**INTERIM MEASURES WORK PLAN
EAST HELENA FACILITY**

April 1999

**RESPONSE TO EPA COMMENTS
ON INTERIM MEASURES WORK PLAN
EAST HELENA FACILITY**

FIGURE
4-1-6

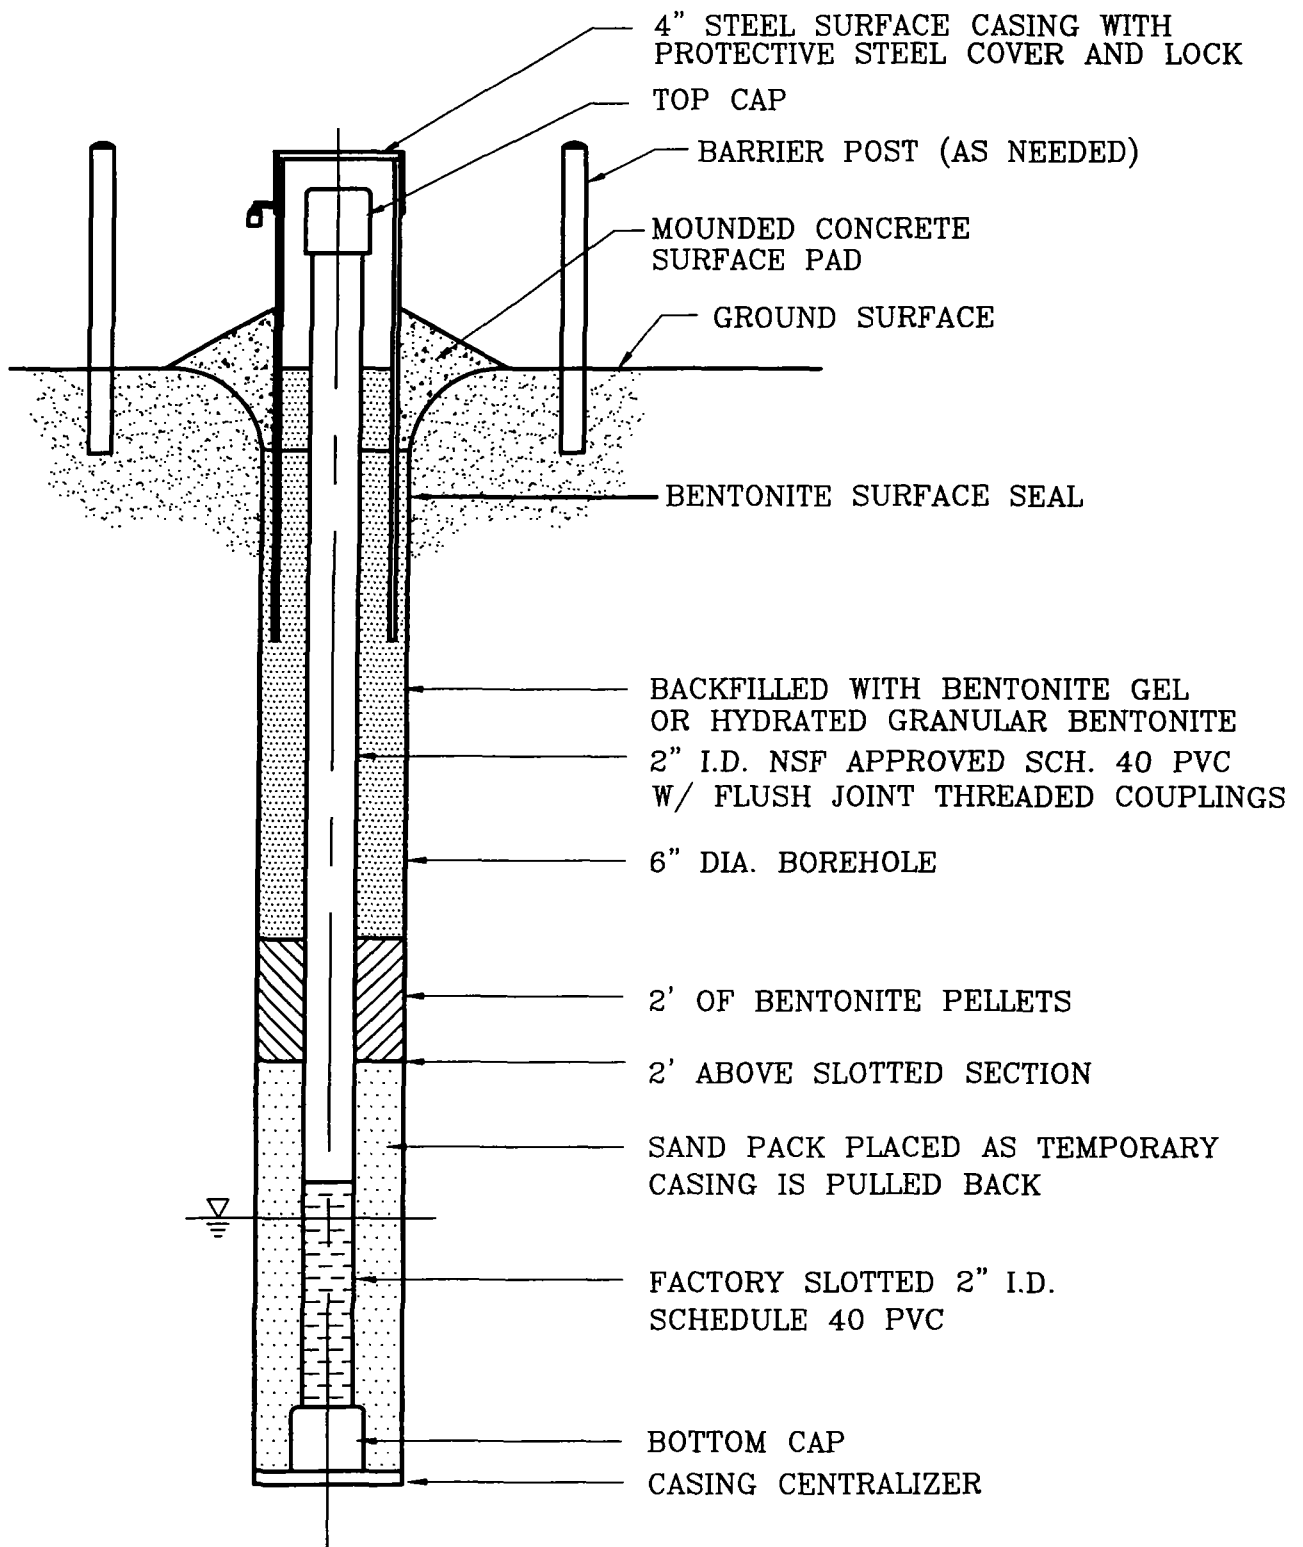
Specific Comment 7. Page 4-15, Figure 4-1-6. Figure 4-1-6 shows monitoring well construction details. This figure should be modified to indicate that well screen will be located below water table as stated on page 4-14.

Response: The report text requires clarification. The well screens will be completed across the water table not below the water table as presently indicated. The text, figures, and tables have been checked and revised for consistency.

FIGURE 7-1-2 INTERM MEASURES IMPLEMENTATION SCHEDULE

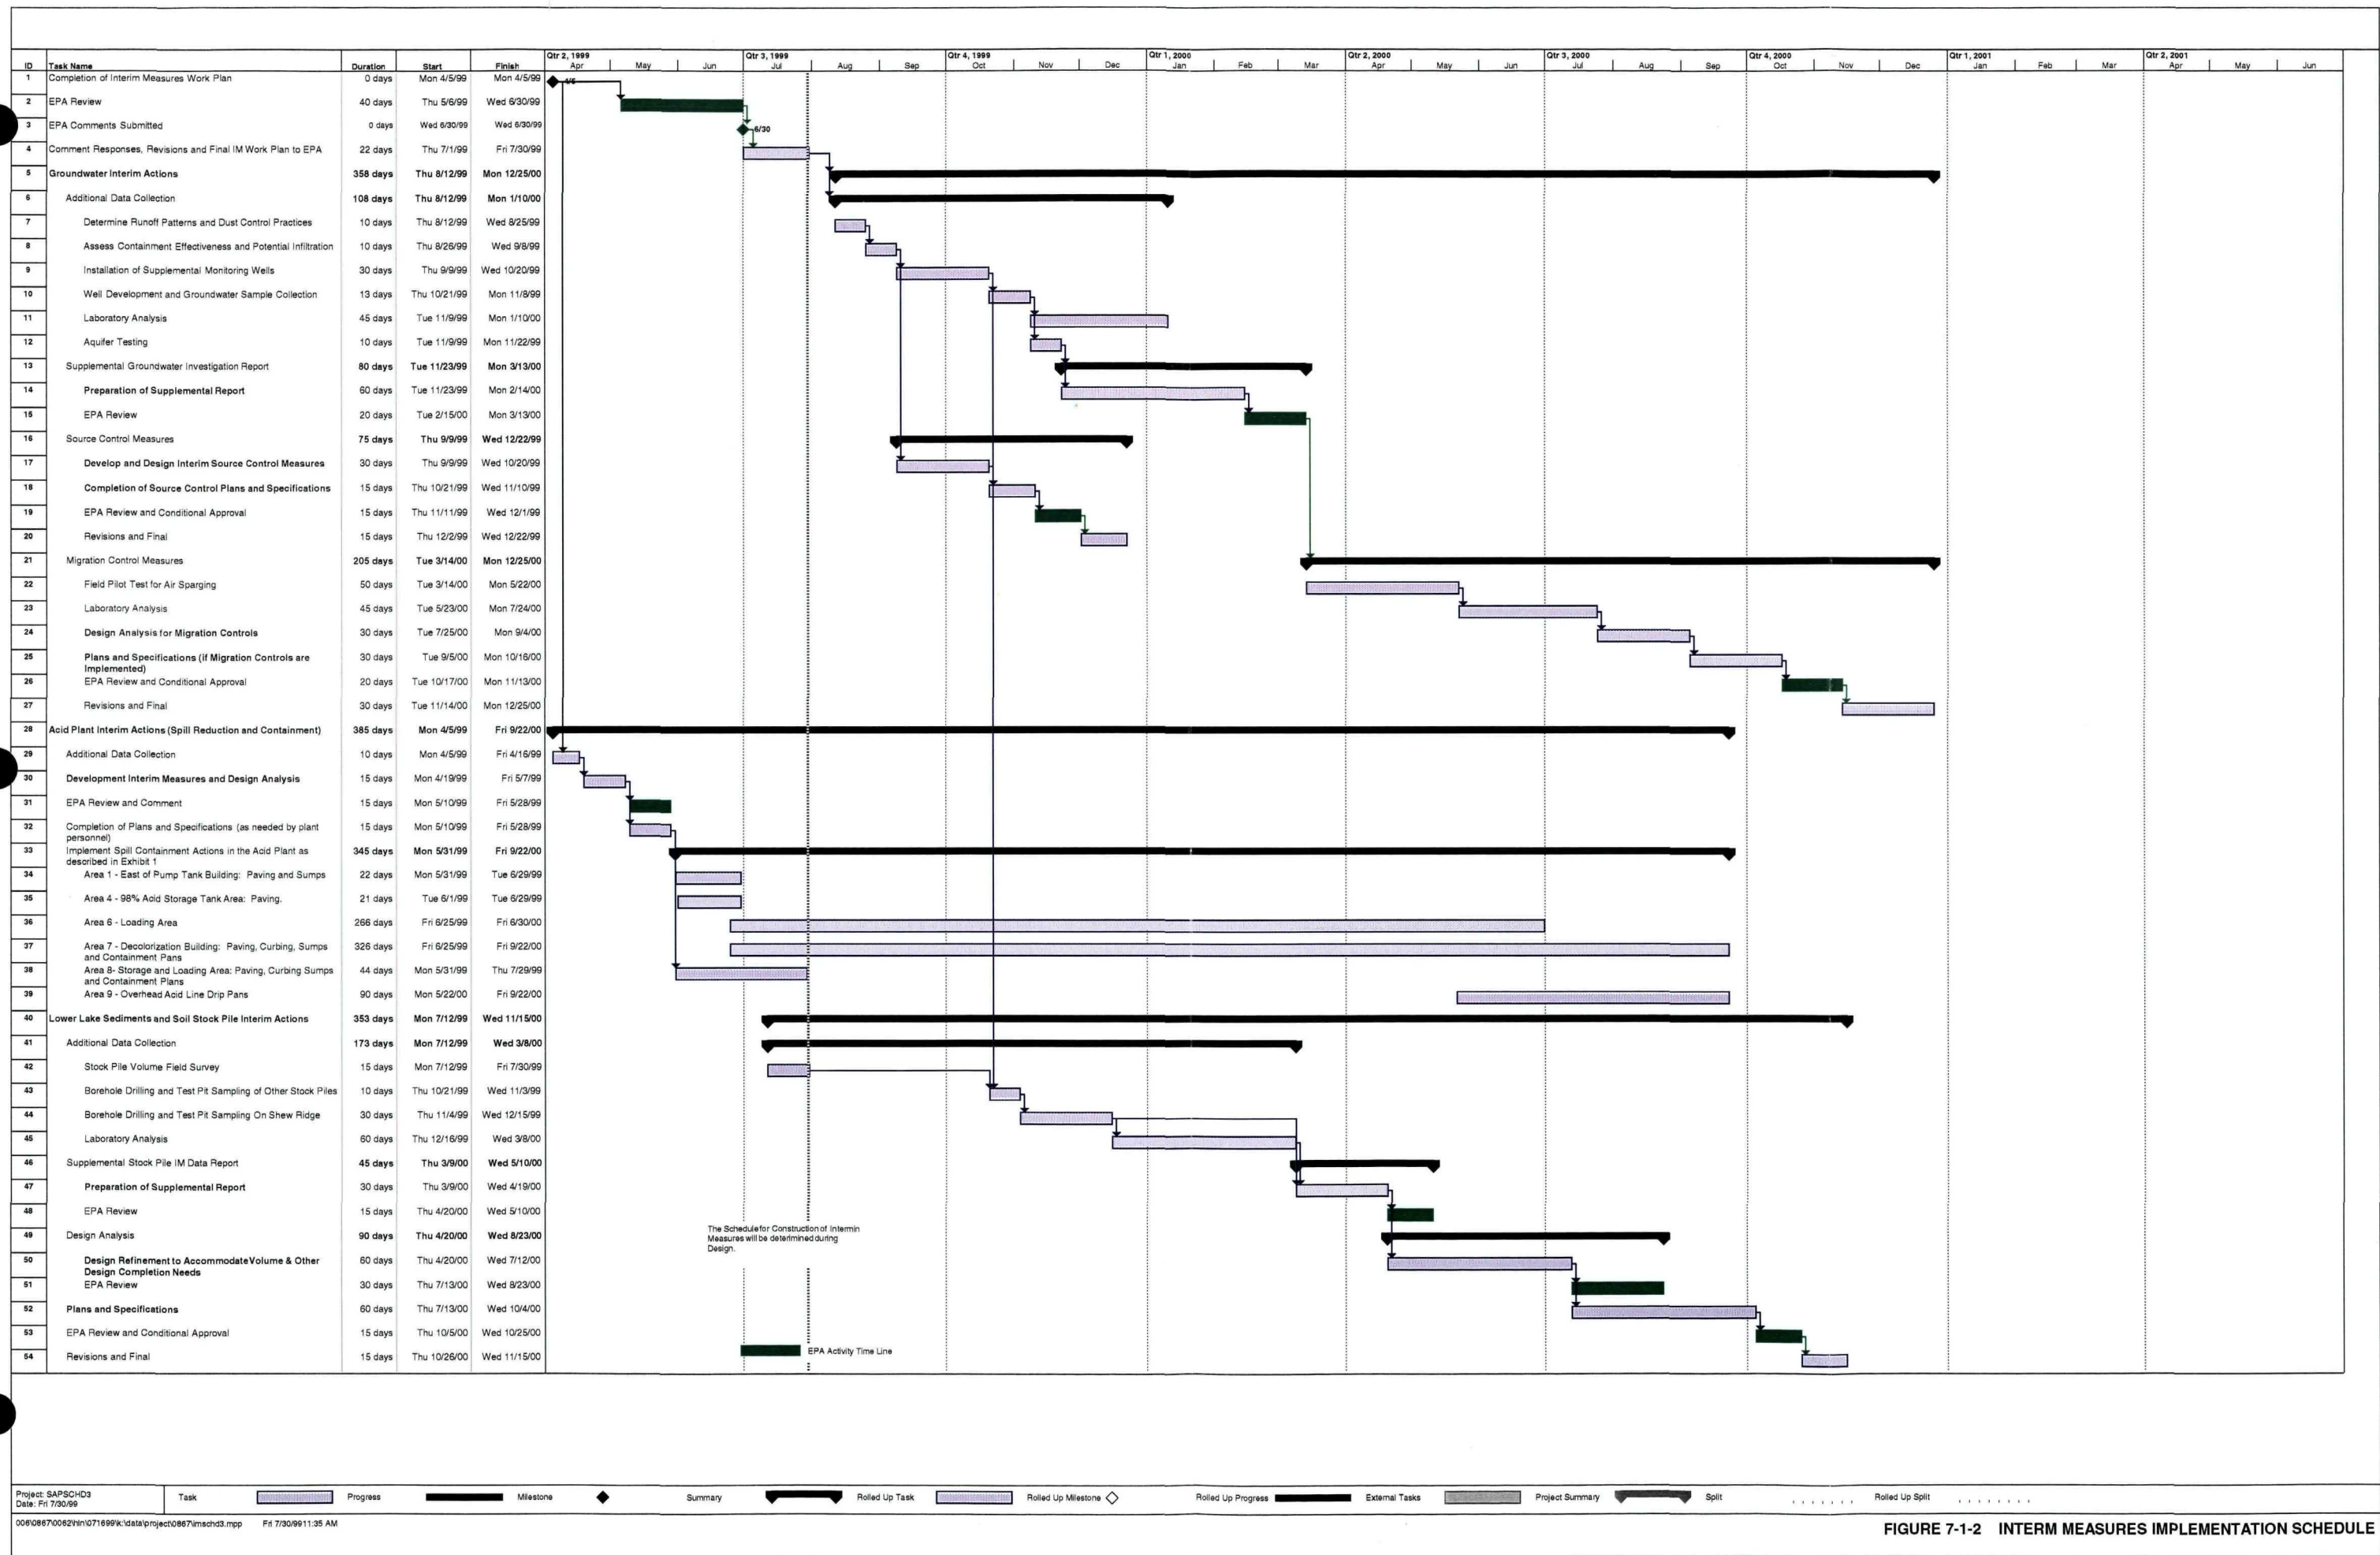
Specific Comment 14. Figure 7-1-2. Include the EPA review (green) time in the key.

Response: The figure has been modified as indicated.
